ADDENDUM NO. 1

March 19, 2025

School District of Haverford Township | Coopertown Elementary School Renovations & Additions
CRA Project No. 3758

A4.5

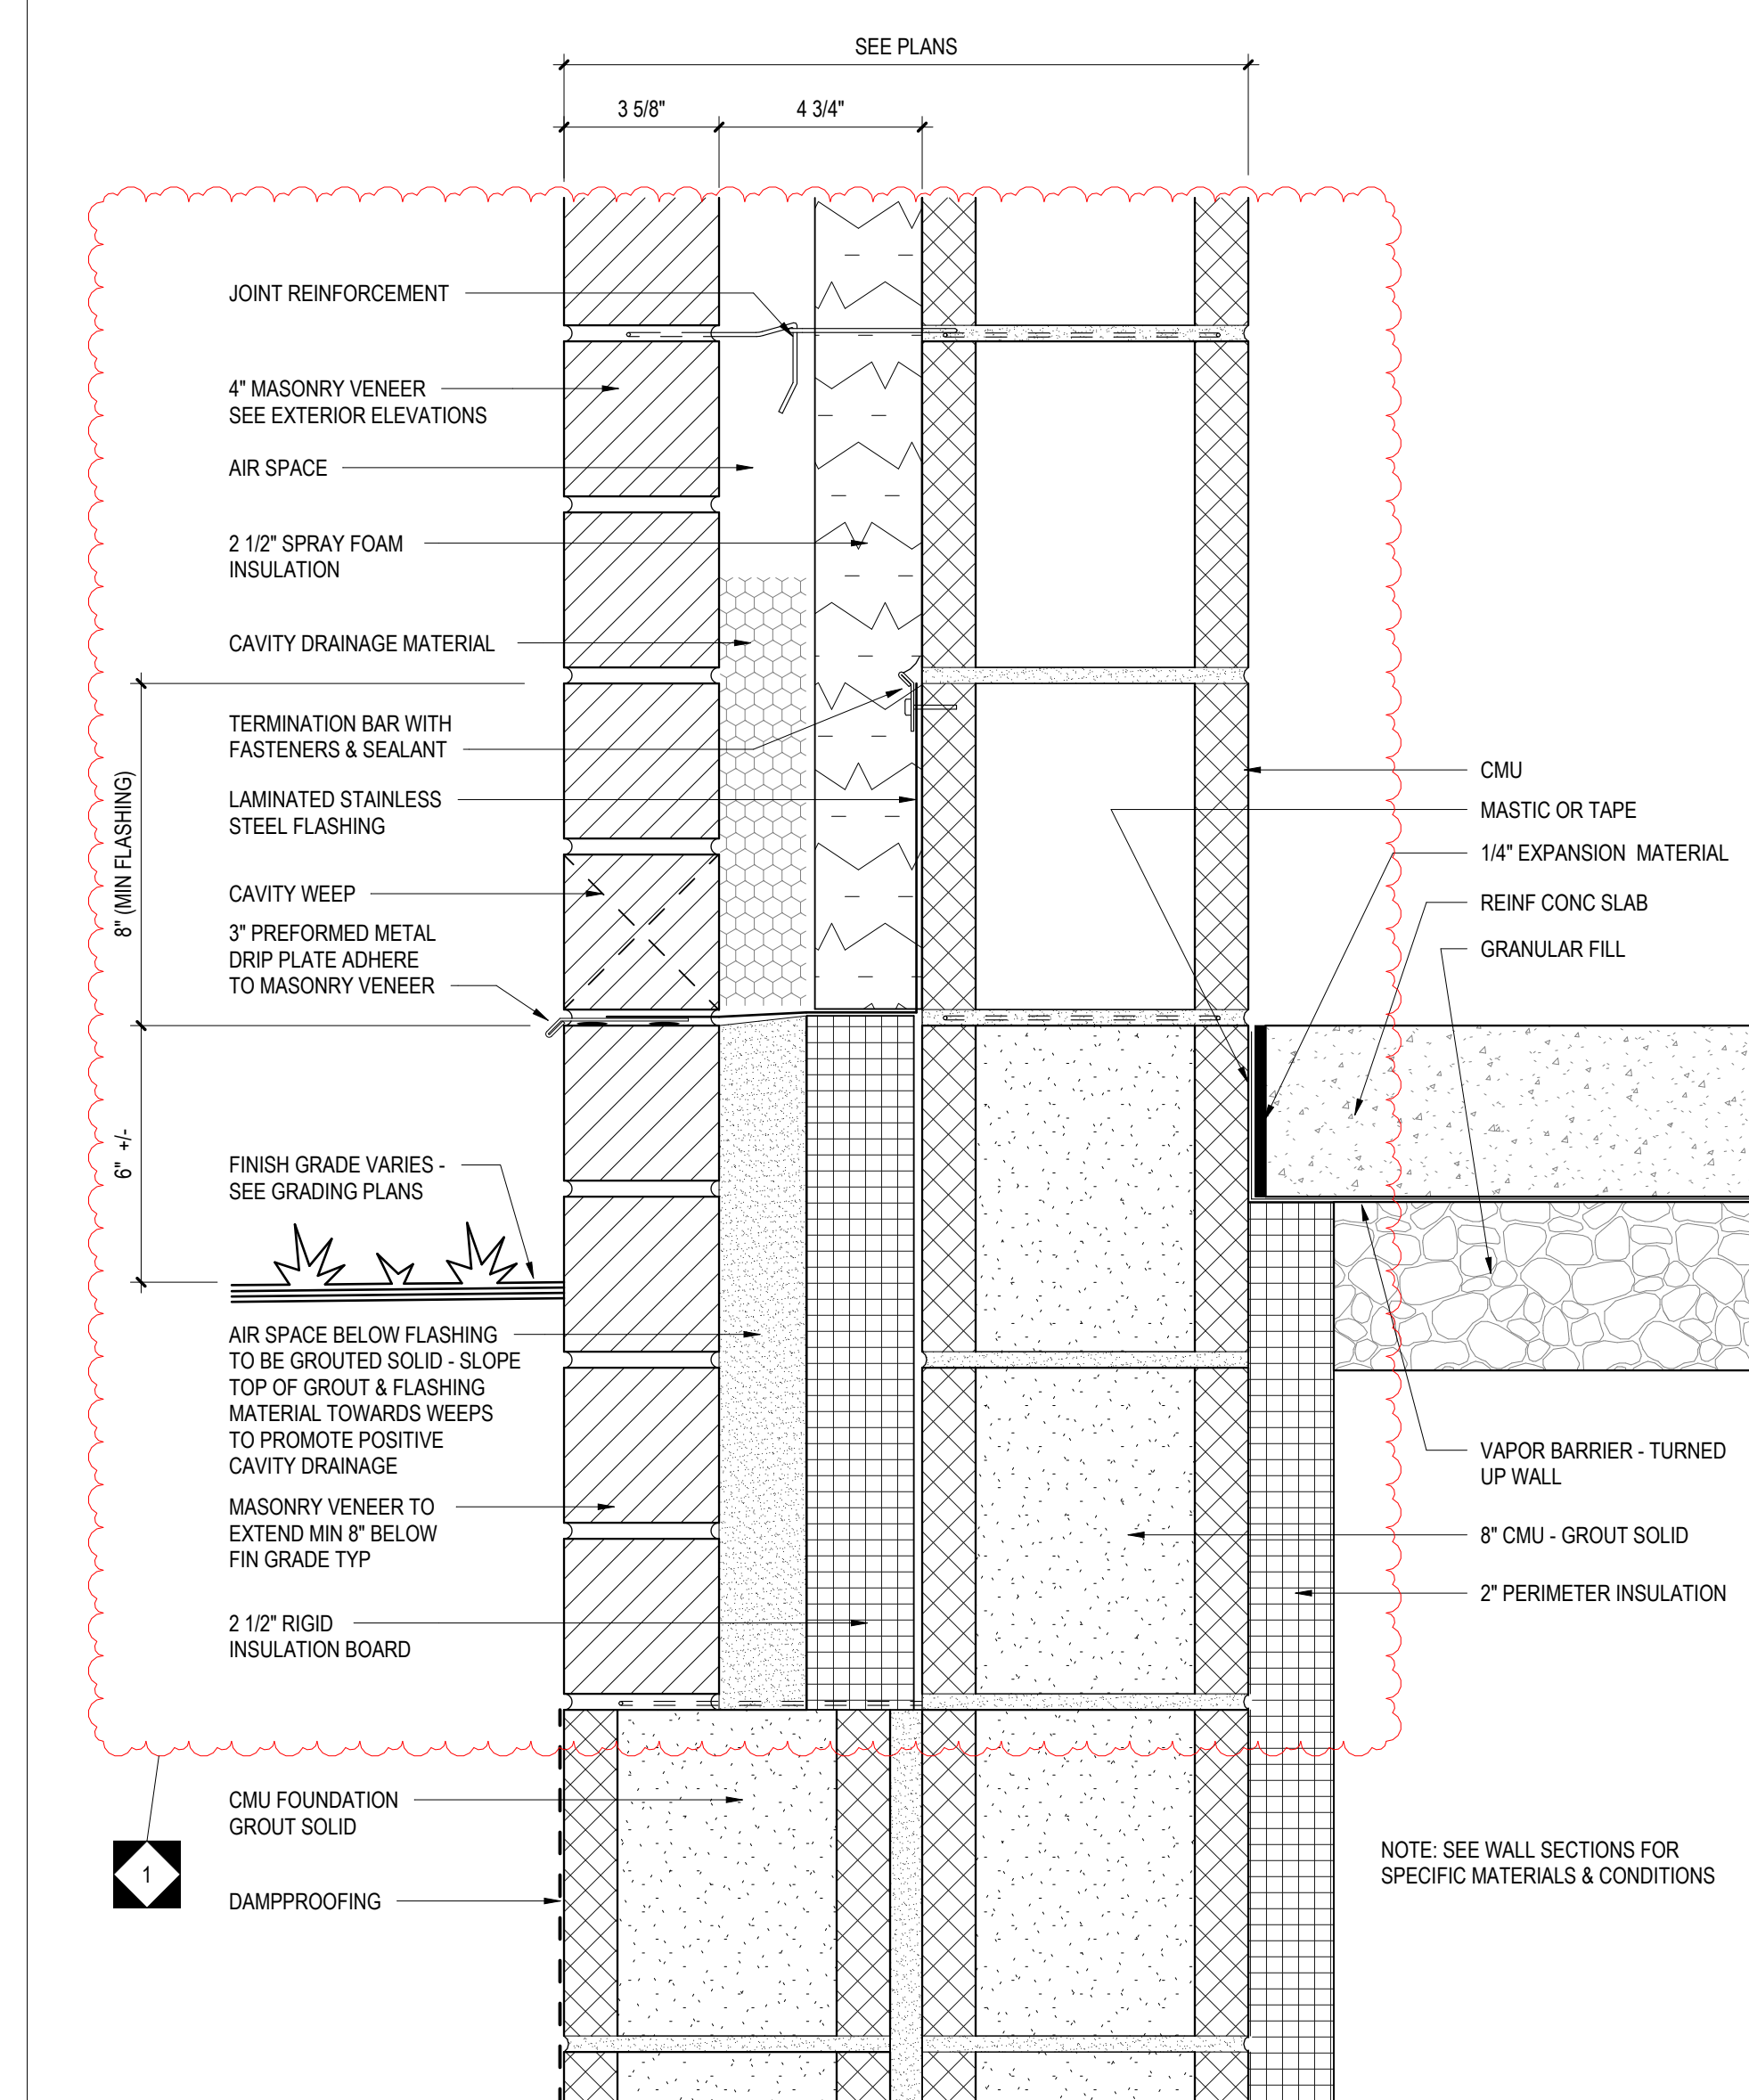
1. ADD – note to boulders and stone bed
2. REMOVE – bench at front entrance
